Access Compliance Report Public Rights-of-Way (Curb Ramps)

Main Street: SLEEPY_HOLLOW_LN Cross Street: VINEWOOD_LN Location: NE

ADA ID: RPRK211021134557 Ramp Type: Type 4 - Parallel Initial Pass/Fail: Pass Overall Compliance: No Severity Score: 20

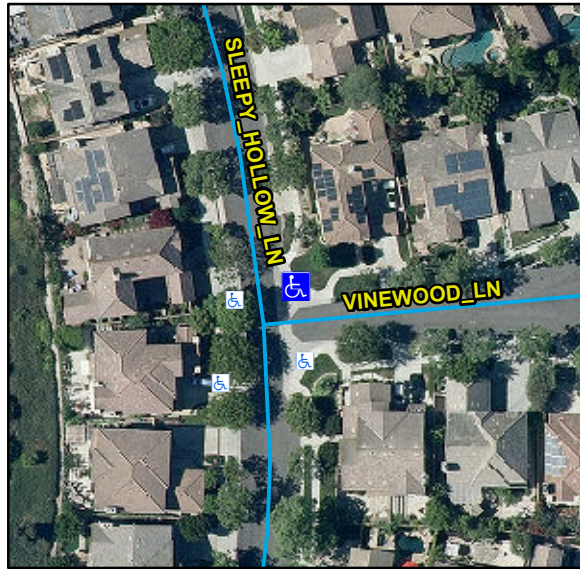
Compliance	Description	Data	Compliance	Description	Data
N/A	Ramp Length LT (in)	116	N/A	Ramp Length RT (in)	117
Yes	Ramp Width LT (in)	54	Yes	Ramp Width RT (in)	53
Yes	Ramp Run Slope LT (%)	4.7	Yes	Ramp Run Slope RT (%)	7.9
Yes	Ramp Cross Slope LT (%)	0.5	Yes	Ramp Cross Slope RT (%)	0
N/A	Landing Present	No	No	DWS Provided	No
N/A	Landing Length (in)	N/A	N/A	DWS Contrast	N/A
No	Landing Width (in)	N/A	N/A	DWS Length (in)	N/A
No	Landing Run Slope (%)	N/A	N/A	DWS Full Width	N/A
No	Landing Cross Slope (%)	N/A		DWS Offset Type	N/A
N/A	Landing Movement Obstructed?	No	N/A	DWS Offset Left (in)	N/A
	Landing Movement Type	Curb	N/A	DWS Offset Right (in)	N/A
N/A	Landing Shared	N/A			
N/A	Clear Space	Yes			
N/A	Clear Space To Crosswalk (in)	48			
N/A	Marked Crosswalk 1	No	N/A	Marked Crosswalk 2	No
	Crossing 1 Direction	W		Crossing 2 Direction	S
	Marked Crosswalk 1 Width (in)	N/A		Marked Crosswalk 2 Width (in)	N/A
N/A	Ramp Inside Crosswalk 1	N/A	N/A	Ramp Inside Crosswalk 2	N/A

Crossing 1 Slope (%)	3		Crossing 2 Slope (%)	1.6
	Crossing 1 Cross Slope (%)	1		Crossing 2 Cross Slope (%)	3.6
Yes	Gutter Ponding	No	Yes	Curb Slope	5.4
Yes	Gutter Lip Height (in)	0		Road Run Slope (%)	0.7
Yes	Gutter Run Slope (%)	3.5		Road Cross Slope (%)	6.6
Yes	Gutter Cross Slope (%)	0.2	No	Perpendicular Joint Present	No
Yes	Overall Surface Condition	Acceptable			
	Cross Gutter Present?	Yes		Spandrel Present?	Yes
	Replace Cross Gutter?	No		Replace Spandrel?	No

Remove & Replace Curb Ramp With Two New Directional Ramps or Equivalent.
